ARDEN SENIOR LIVING CENTER

SITE DEVELOPMENT PLAN

PROJECT NUMBER: SPEC23422

DATE: JANUARY 03, 2023

GRADING AND STORM DRAINAGE PLAN - AREA "A"

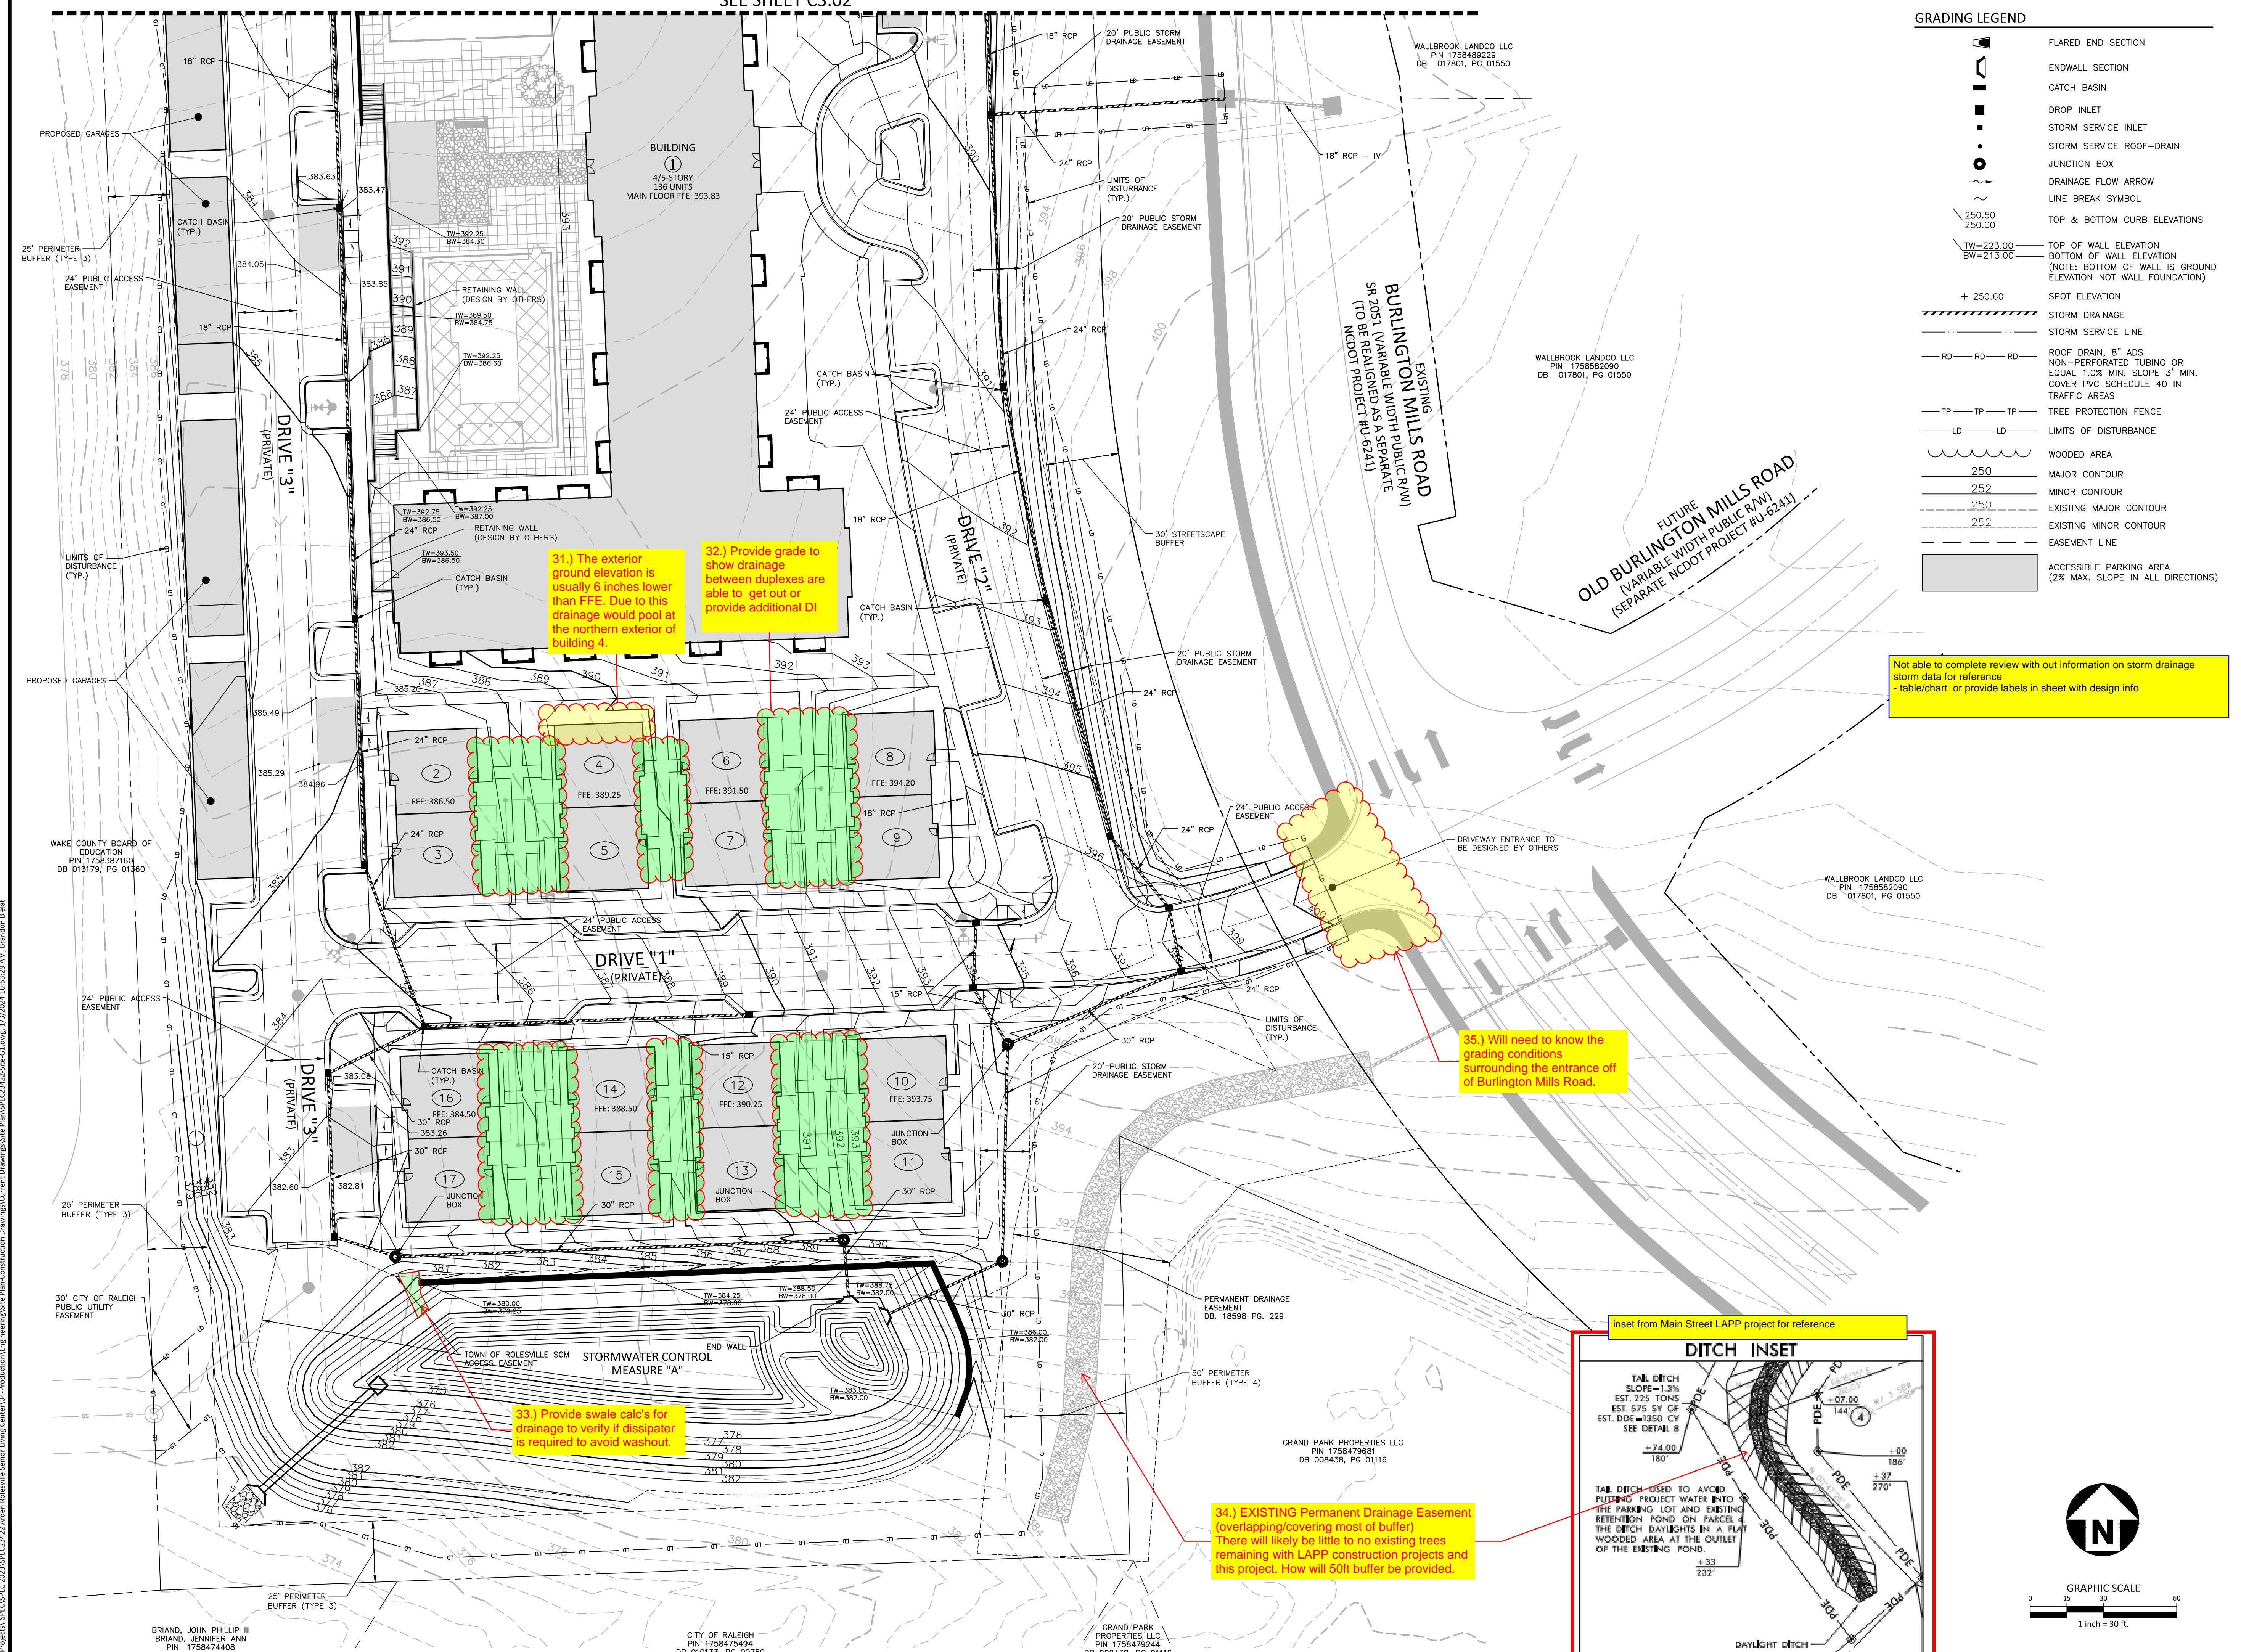
Not able to complete review with out information on storm drainage storm data for reference - table/chart or provide labels in sheet with design info
